Subject: Amendment to SNM 777

Please amend License SNM 777 to incorporate changes as indicated on  
the attached revised pages and drawings.

**SUBJECT: PROCESSING - FACILITIES AND EQUIPMENT**

**302.8 Uranium Bearing Scrap Containing Combustible or Volatile Material**

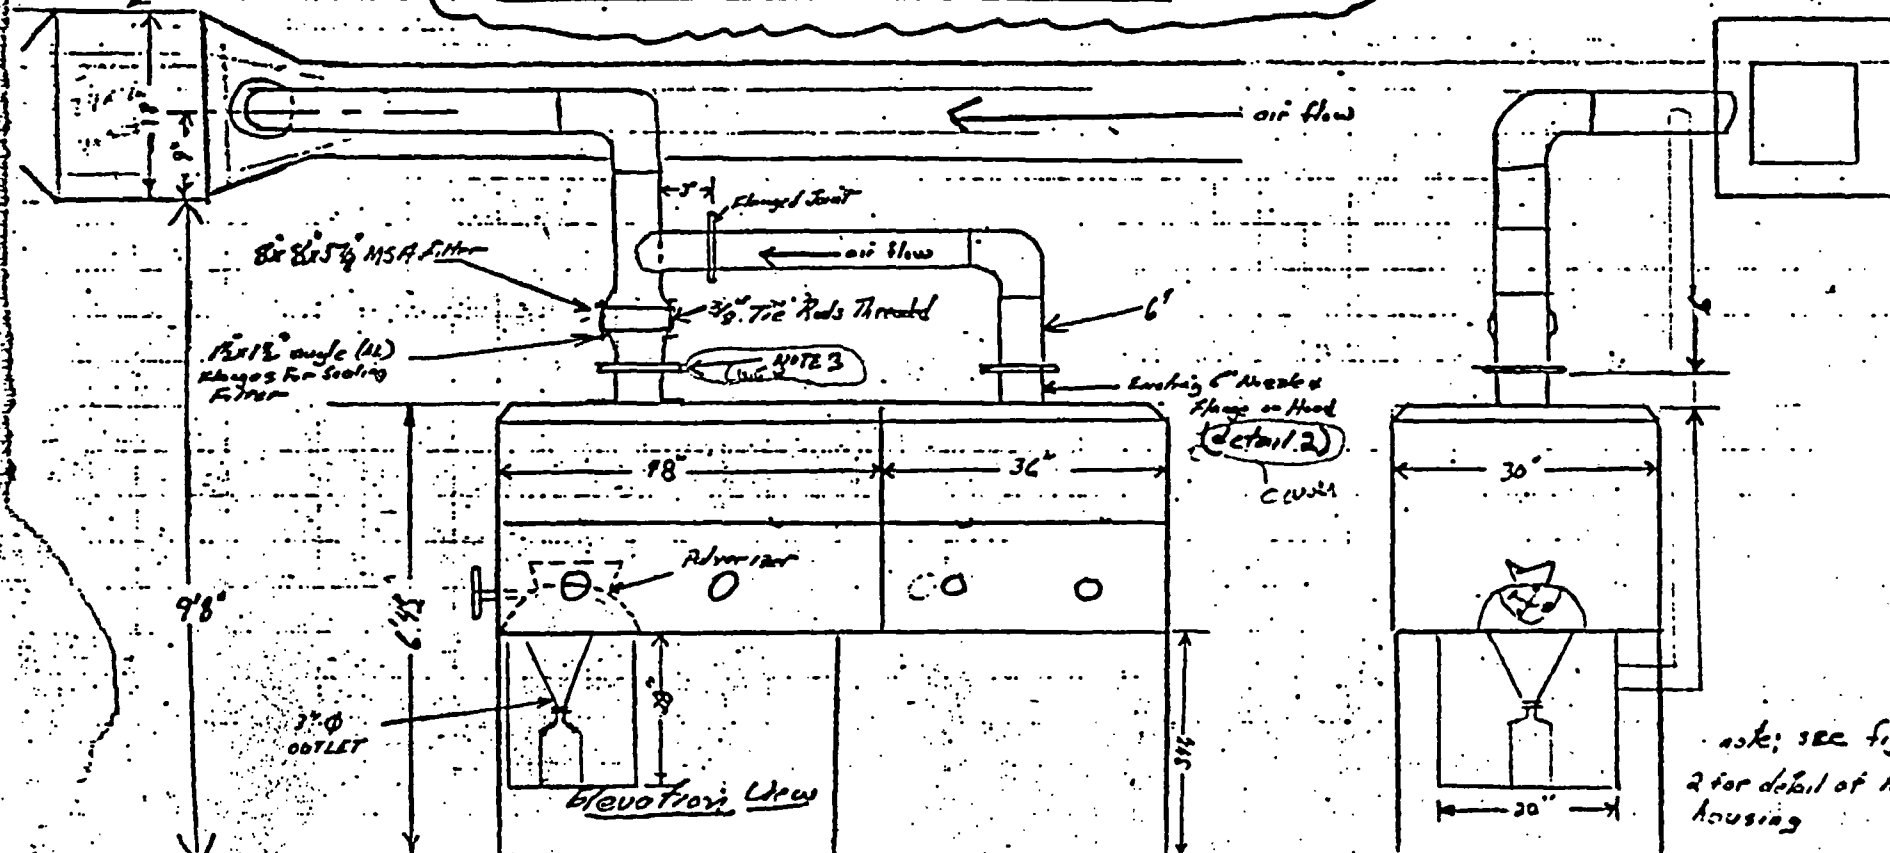
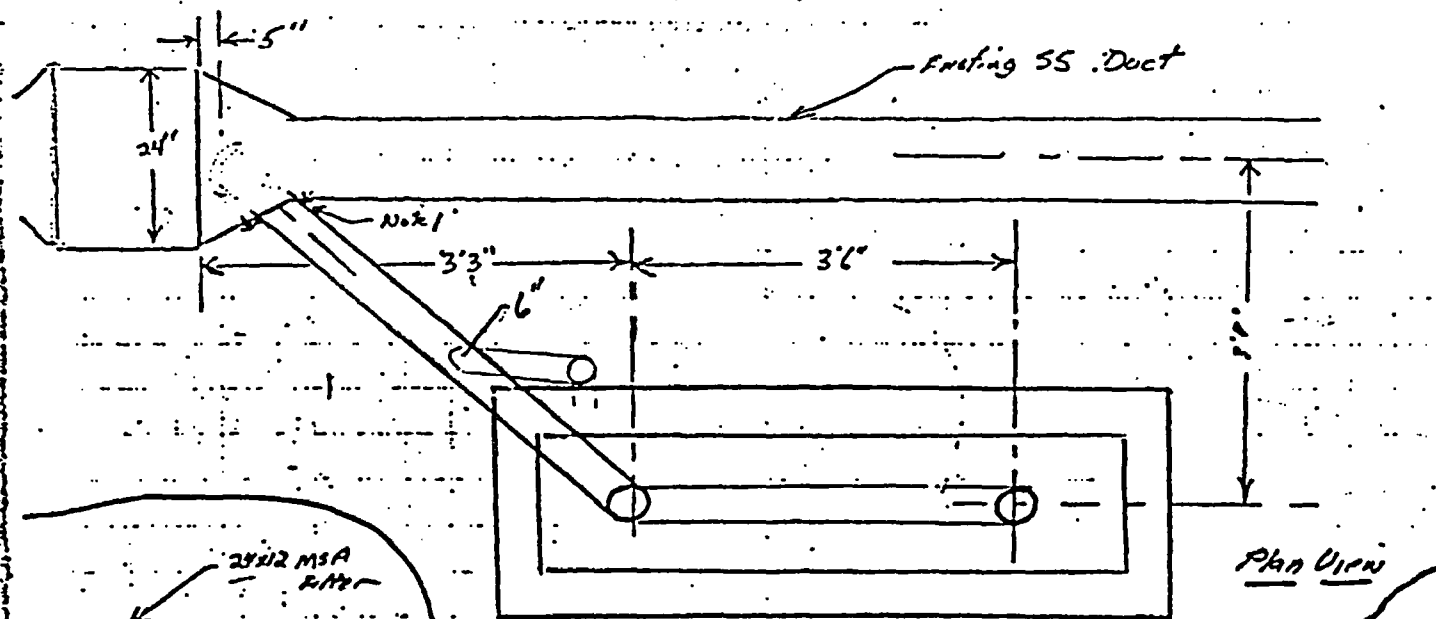
This Hood is 30" deep x 84" long x 42" high. The section housing the Pulverizer is 48" long and is connected to the adjacent chamber by a sliding vertical door. The drive motor for the Pulverizer is externally mounted. Ventilation to the Hood is provided by three ducts leading from each end of the Hood and the withdrawal chamber to an existing exhaust system. The air from the Pulverizer chamber is filtered through an 8 x 8 x 5-7/8 absolute filter before entering the present exhaust system which has additional filtering. The air from the entrance and withdrawal chamber passes into the present exhaust system before additional filtering. See Figure 1 and 2.

# DIAGRAM 2

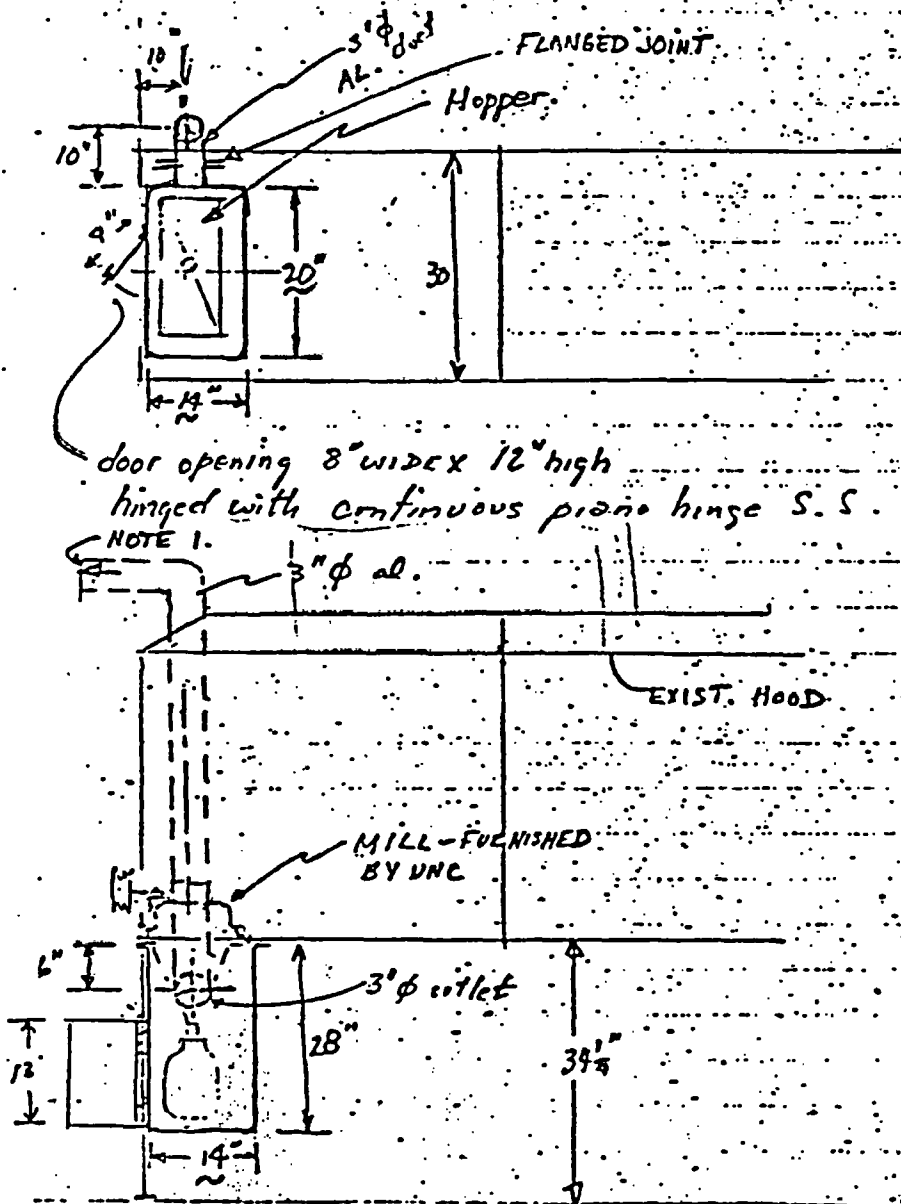
note: see figure 2 for detail of hopper housing

1. Connect, 3"  $\phi$  Al. duct to 6" duct as shown on RI 386 INQUIRY.

2. Material of const. 18-8 type S.S.

door opening 8" wide x 12" high hinged with continuous piano hinge S.S. and latched at top & bottom.

UNITED NUCL  
CORPORATION  
CHEMICAL DIVIS  
SCRAP RECOVERY FA  
EQUIPMENT LAYOUT PLANS

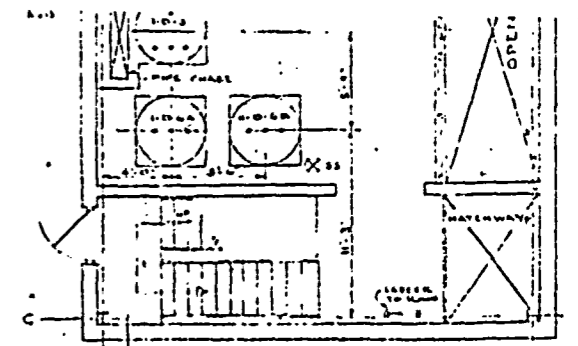
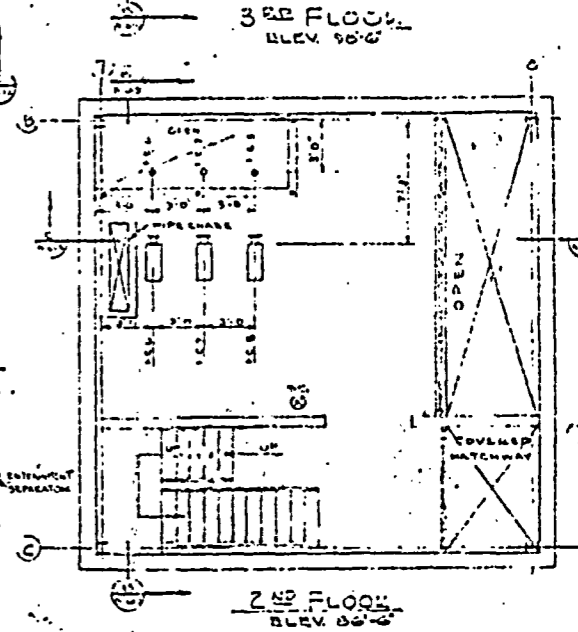
Uranium compounds with uranium density equal to or less than 3.2 gms/cc will be converted to uranium oxides, by discharging pulverized powder into a vertical tube together with oxygen rich gas, collected in portable containers, and dissolved in nitric and/or other acids to make uranium solutions which will be processed as described elsewhere in the license. The location of this equipment is shown in attached Drawing 602/3 as revised. Equipment is shown in Figure 3.

This Hood sets 3' off the floor and is located 4' north of 1-L-9 and 10' south of 1-D-41. The west end of the Hood is contiguous to Column 6E. Drawing A602/Rev is attached showing this location. The materials are collected in the 5 ID x 12 long hopper container (2-X-1, 2, 3, 4, 5) or 1 gallon bottles.
